TANK RELOCATION

**ON-SITE SEWAGE DISPOSAL SYSTEM
HOWARD COUNTY HEALTH DEPARTMENT
BUREAU OF ENVIRONMENTAL HEALTH**

SUBDIVISION: The Paddocks LOT NUMBER: 28-36

ADDRESS: 3709 Bold Ruler Court PROPERTY OWNER: Pulte Homes, Inc

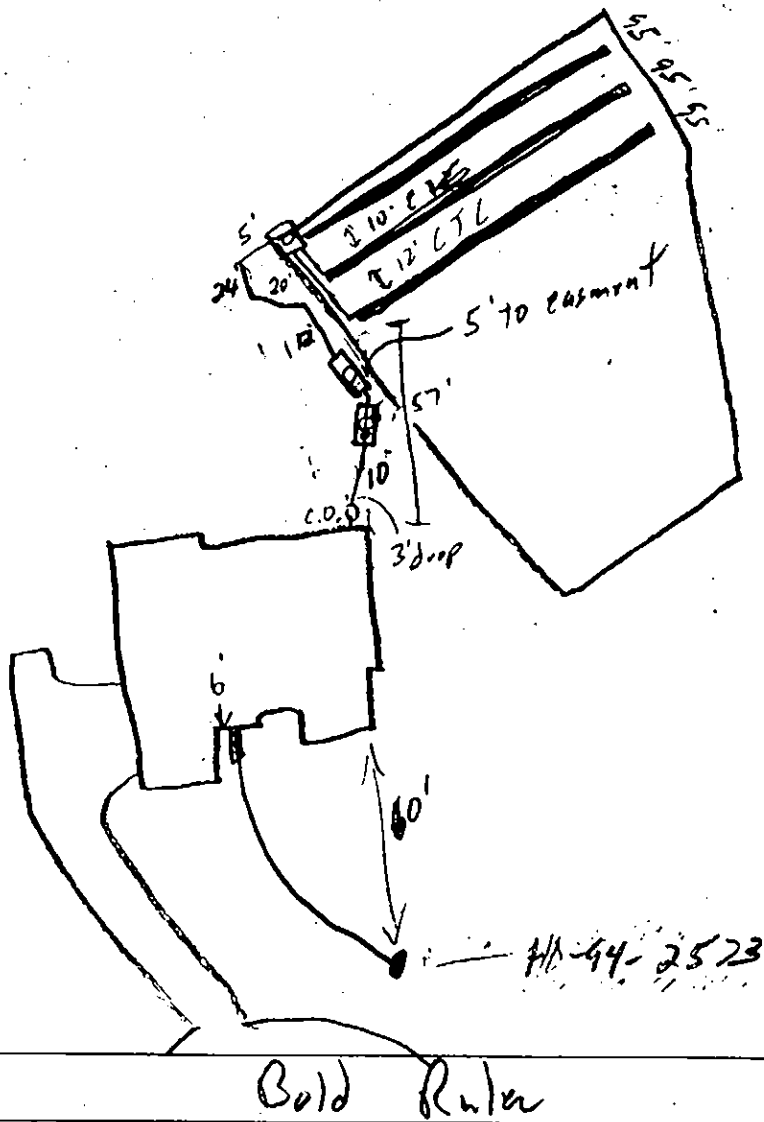
PRE-CONSTRUCTION 6/26/02 Lot staked, OK to have trenches 6" deep at far end of SRA. 10' etc 100' / 40' / 90' (SO)

INSTALLATION 6/26/02 OK to cover all work. Pump & Alarm test needed (SO) 7/18/02 OK to move ST & PT closer to the house & to the right of house down. Must maintain 5' from SRA, 20' from pool, 10' from house (SO) 7/19/02 Tanks moved, OK to cover (SO) 8/9/02 Pump & Alarm tests OK (SO)

Approved Septic System Plan
 Howard County Health Department
 15-02-13 OK

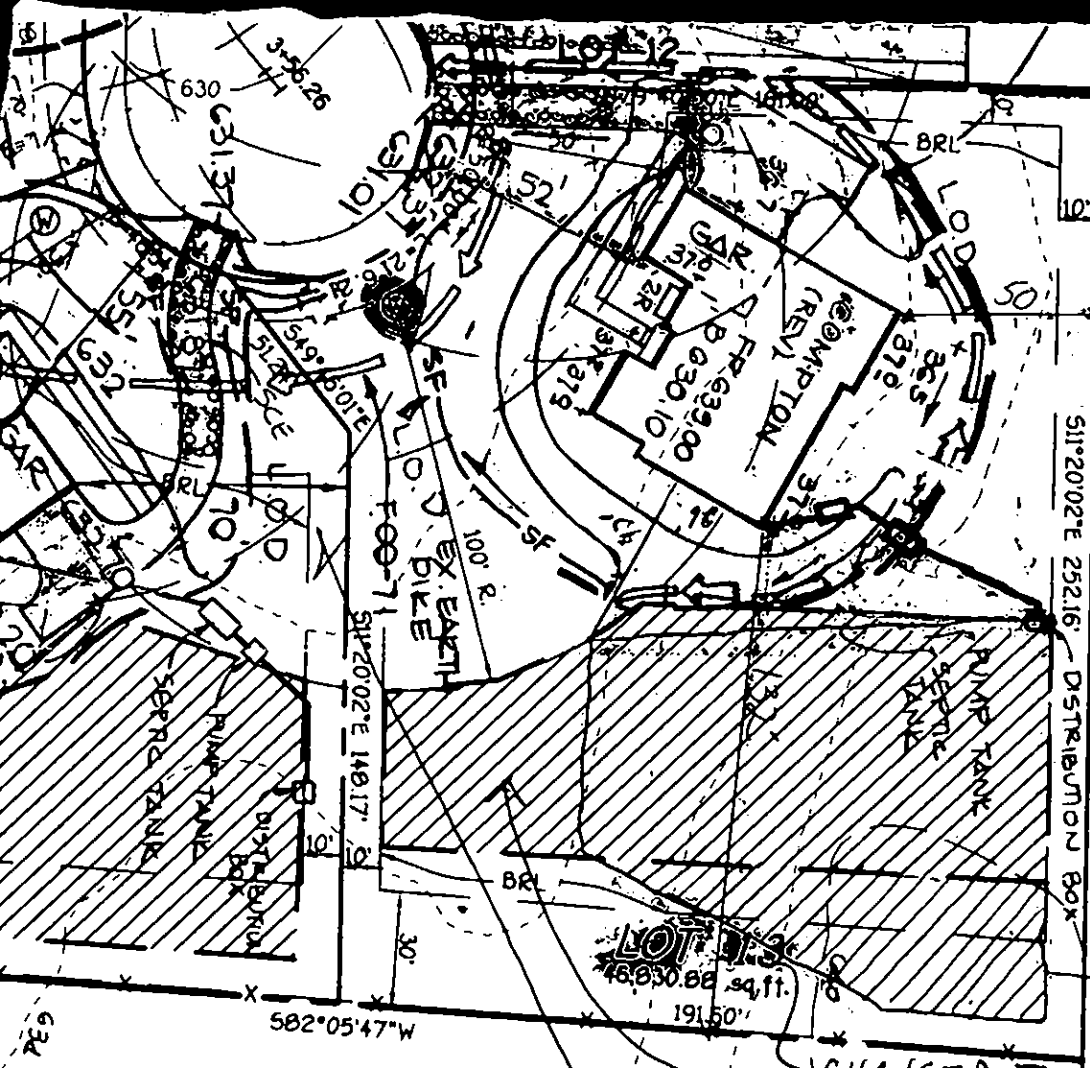
Revised
 Septic
 Easement
 Per ~~Record~~
~~Record~~ ~~Plat.~~
 Revised
 Paddocks
 Record
 Plat.

SDA Area - Deleted

CHANGED TO LOT 36

HOUSE LOCATION DRAWING

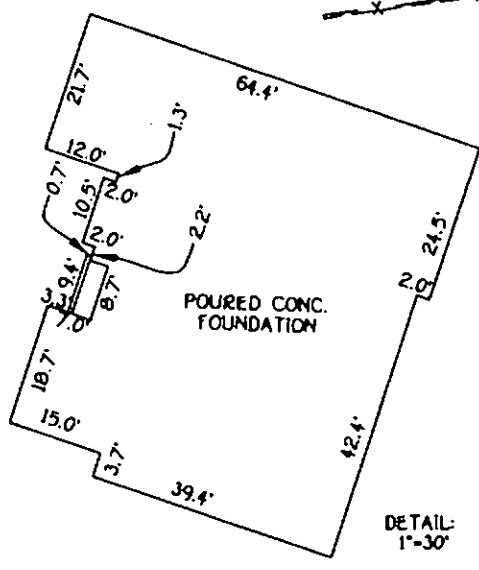
*WALL CHECK
OK, BUT
NEED NEW
BP PLAN
MR 5/7/02*

LOT 12
THE PADDOCKS
PLAT No. 14482
F-00-71
ZONED: RR-DEO
*Builder was notified
re: this revised plat
4/25/02
Resolved*

LOT 36
 THE PADDOCKS
 LOTS 36, 37 AND NON-BUILDABLE LOT 38
 PREVIOUSLY RECORDED AS PLAT No. 14482
 THIRD ELECTION DISTRICT
 HOWARD COUNTY, MARYLAND
 PLAT No. 15358
 B.R.L.=BUILDING RESTRICTION LINE
 TOP OF FOUNDATION ELEV. 638.1'

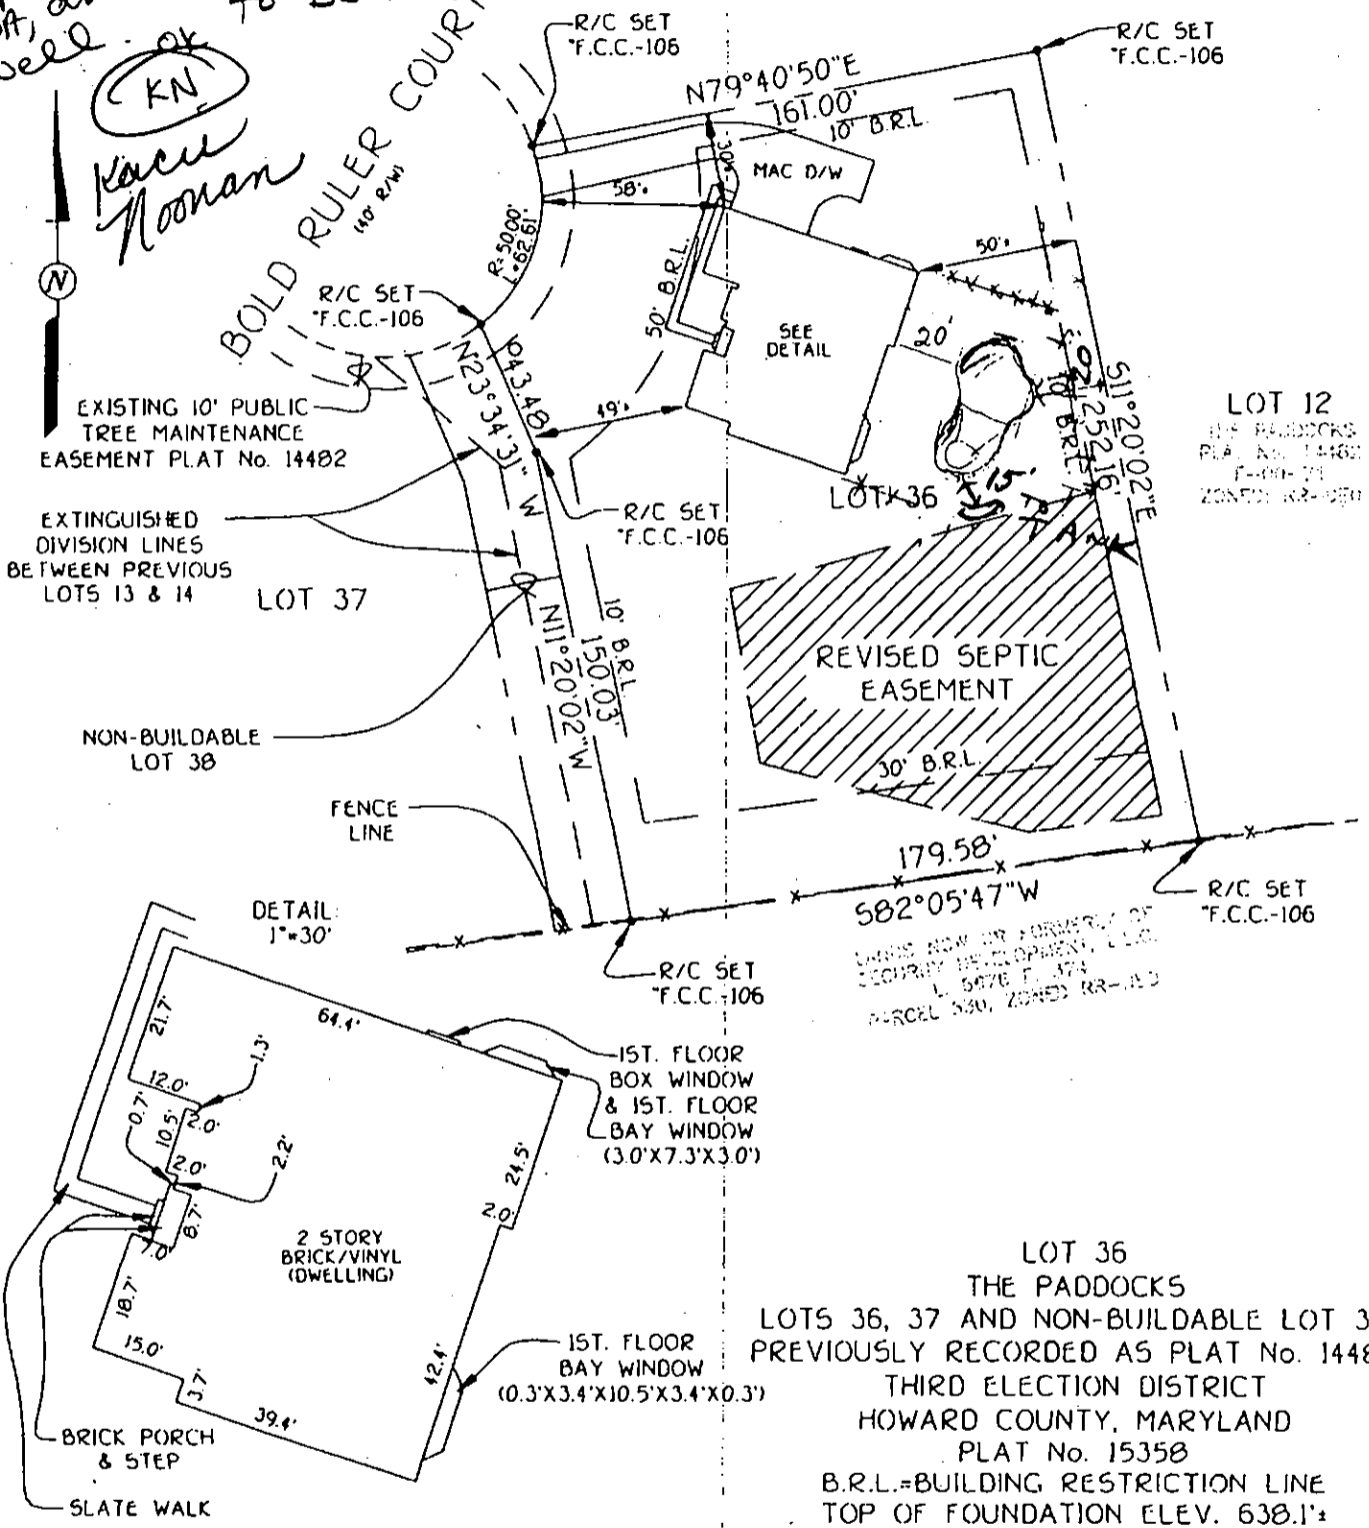
8/19/03
 pool location
 OK from
 septic tanks,
 SDA, and
 well

Permit on hold
 With Joe Williams
 in Howard Co.
 permit dept.
 permit # B00143187
